# UNITED STATES PATENT AND TRADEMARK OFFICE

APPLICATION NO.	FILING DATE	FIRST NAMED INVENTOR	ATTORNEY DOCKET NO.	CONFIRMATION NO.
10/025,009	12/19/2001	Martin Wiesler	1944	3574

**Office Action Summary**

## **DETAILED ACTION**

Fig. 2  
PRIOR ART

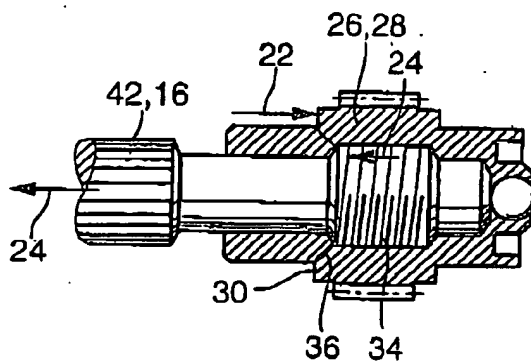
Re: claim 6, Winter's drive unit, as rejected in claim 1 above, is silent of a threaded bead formed on said driven shaft. Figure 2 of the submitted prior art teaches a threaded bead 34 formed on driven shaft 42, which has an outer diameter greater than the outer diameter of the driven shaft. With a modified driven shaft comprising a bead as taught by figure 2, said bead's outer diameter would be greater than the inner diameter of the supporting element 52. It would have been obvious to one of ordinary skill in the art at the time the invention was made to have modified Winter's drive unit to include a threaded bead on the driven shaft as taught by figure 2 of the submitted prior art in order to provide a more secured connection between the driven shaft and the driven wheel as taught by figure 2 of the submitted prior art.

Winter et al. meet all the claimed structural limitations of claim 22. Winter is silent of a threaded bead formed on said driven shaft. Figure 2 of the submitted prior art teaches a threaded bead 34 formed on driven shaft 42, which has an outer diameter greater than the outer diameter of the driven shaft. With a modified driven shaft comprising a bead as taught by figure 2, said bead's outer diameter would be greater than the inner diameter of the supporting element 52. It would have been obvious to one of ordinary skill in the art at the time the invention was made to have modified Winter's drive unit to include a threaded bead on the driven shaft as taught by figure 2 of the submitted prior art in order to provide a more secured connection between the driven shaft and the driven wheel as taught by figure 2 of the submitted prior art.

Re: claim 6, Wittig's drive unit, as rejected in claim 1 above, is silent of a threaded bead formed on said driven shaft. Figure 2 of the submitted prior art teaches a threaded bead 34 formed on driven shaft 42, which has an outer diameter greater than the outer diameter of the driven shaft. With a modified driven shaft comprising a bead as taught by figure 2, said bead's outer diameter would be greater than the inner diameter of the supporting element 38. It would have been obvious to one of ordinary skill in the art at the time the invention was made to have modified Wittig's drive unit to include a threaded bead on the driven shaft as taught by figure 2 of the submitted prior art in order to provide a more secured connection between the driven shaft and the driven wheel as taught by figure 2 of the submitted prior art.
